**Proposal #14: 1228-22-72, WISC 2020 042
IH 43 North South Freeway
Hampton Rd to Bender Rd
IH 43
Milwaukee County**

This is Addendum No. 01, which provides for the following:

ADDENDUM NO. 01

1228-22-72

SHEET 1 OF 5
688

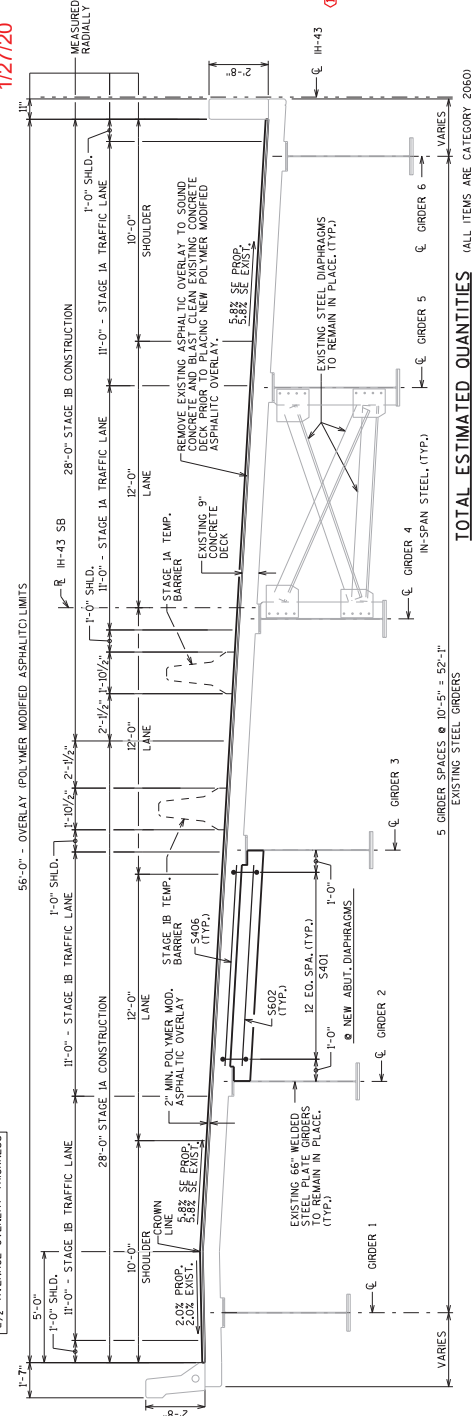
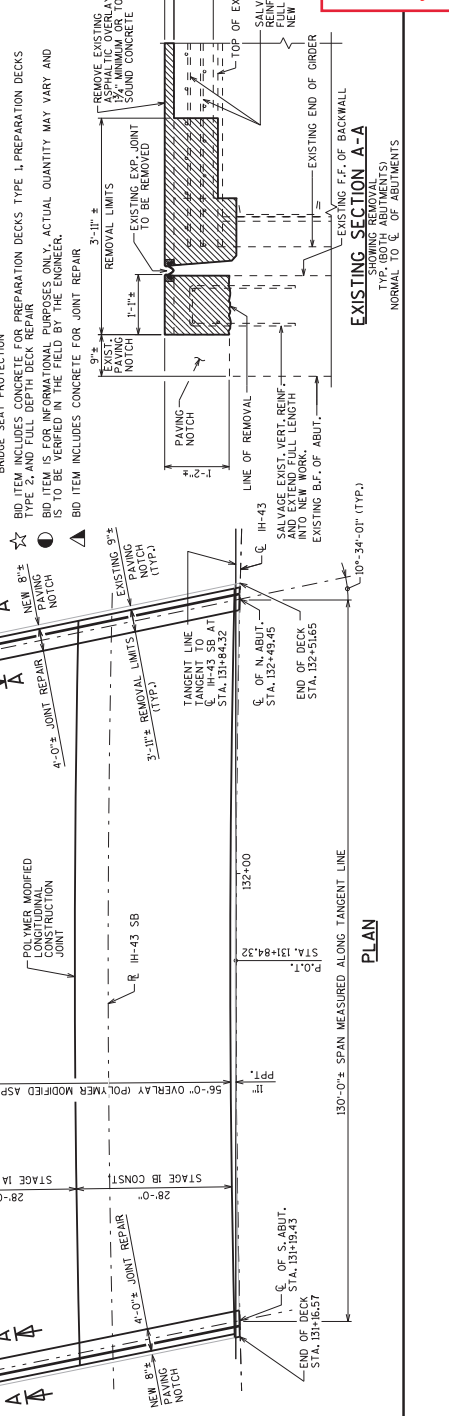
Revised Plan Sheets	
Plan Sheet	Plan Sheet Title (brief description of changes to sheet)
673	Structure B-40-581 revised the color for girder painting in the general notes to use the correct Blue color instead of Brown.
678	Structure B-40-582 revised the color for girder painting in the general notes to use the correct Blue color instead of Brown.
683	Structure B-40-583 revised the color for girder painting in the general notes to use the correct Blue color instead of Brown.
688	Structure B-40-584 revised the color for girder painting in the general notes to use the correct Blue color instead of Brown.
693	Structure B-40-585 revised the color for girder painting in the general notes to use the correct Blue color instead of Brown.
698	Structure B-40-586 revised the color for girder painting in the general notes to use the correct Blue color instead of Brown.
703	Structure B-40-587 revised the color for girder painting in the general notes to use the correct Blue color instead of Brown.

REPAIR ALL EXISTING EXPOSED SUPERSTRUCTURE STEEL - INCLUDING STEEL PLATE REPAIRS - TO A COLOR MATCHING SHERWIN WILLIAMS (SW6523) OR SIMILAR COLOR APPROVED BY THE ENGINEER.
